**SHEARON HARRIS NUCLEAR POWER PLANT, UNIT NO. 1
DOCKET NO. 50-400/LICENSE NO. NPF-63
FREQUENTLY ASKED QUESTIONS (FAQS), REQUESTING ADDITIONAL
GUIDANCE OR CLARIFICATION REGARDING TRANSITION TO NFPA-805
"PERFORMANCE BASED STANDARD FOR FIRE PROTECTION FOR LIGHT
WATER REACTOR ELECTRIC GENERATING PLANTS"**

FAQ 06-0004

**NFPA-805 Transition Pilot Plant
Frequently Asked Questions
(Template)**

Plant:	<u>Harris Nuclear Plant (HNP)</u>	FAQ # <u>06-0004</u>
Submittal Date:	<u>05-12-06</u>	
Licensee Contact:	<u>Jeff Ertman</u>	Tele/email <u>919-546-3681</u>
NRC Contact:	_____	Tele/email _____

Figure B-1 – Process for Determining if an Active Fire Protection Feature is Required for NFPA 805 Chapter 4 Compliance

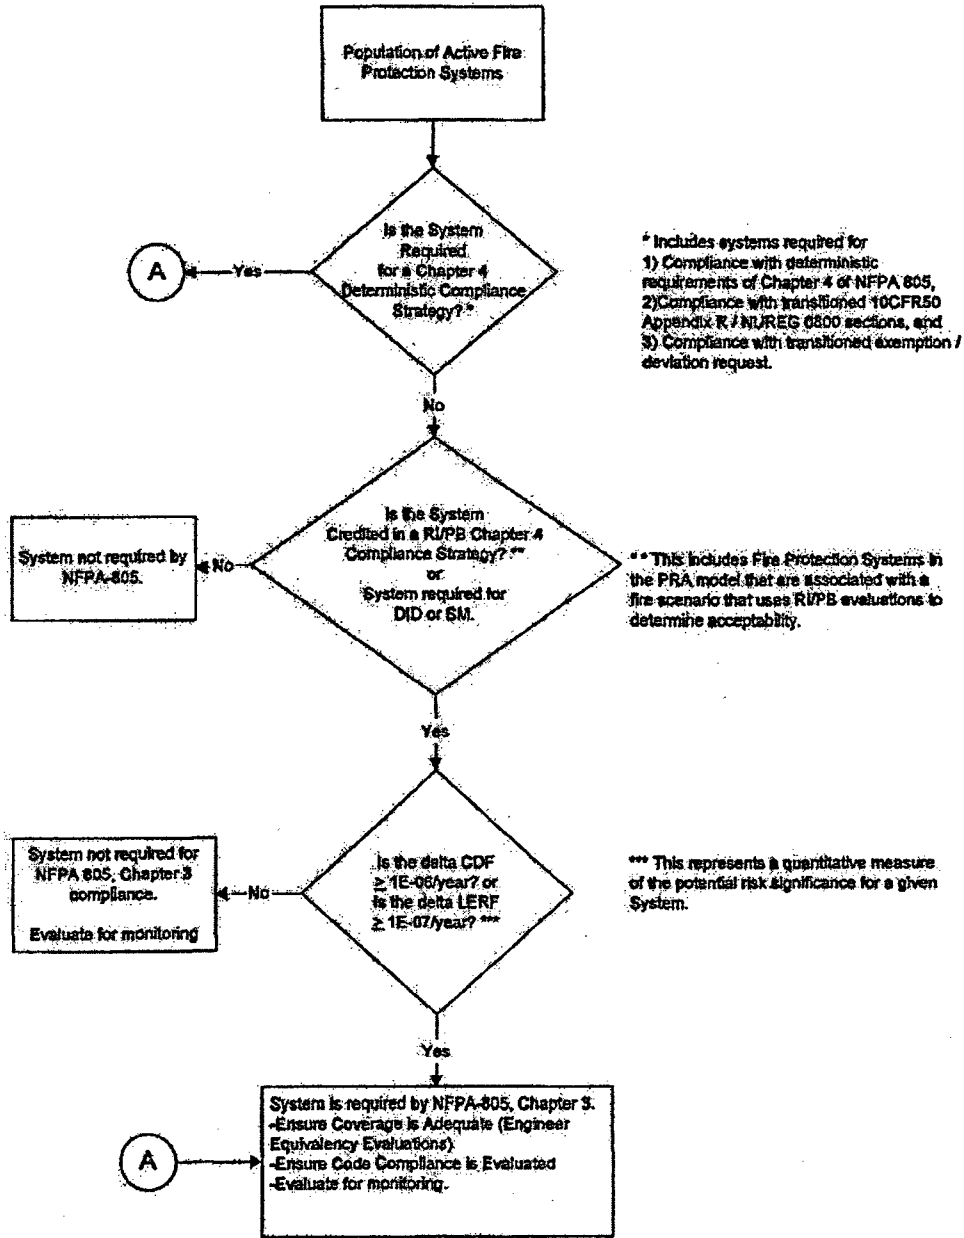
Certain Sections of Chapter 3 are only applicable if the fire protection feature is 'required' to meet the performance or deterministic requirements of Chapter 4. Determining if a fire protection feature is required is an iterative process. Figures B-1 through B-3 depict processes that may be used to determine if the requirements of Chapter 3 are applicable to a particular fire protection feature.

Appendix B Flowcharts (revised, added)

Revised NEI 04-02 Section 5.3.2.4 and Appendix B to include more discussion of requirements for protection and flowcharts (in App. B) to assist in determining which systems and features are 'required' by Ch. 4 of NFPA 805. Certain systems, ERFBS, and fire rated barriers may be required to maintain the configurations assumed during the PRA or are necessary for Defense-in-Depth (DID) or Safety Margin (SM). Therefore, "Evaluate for Monitoring" was left in several flow chart sequences (Figures B-1, B-2, and B-3). Monitoring thresholds and criteria will be developed in detail during the Pilot Plant process.
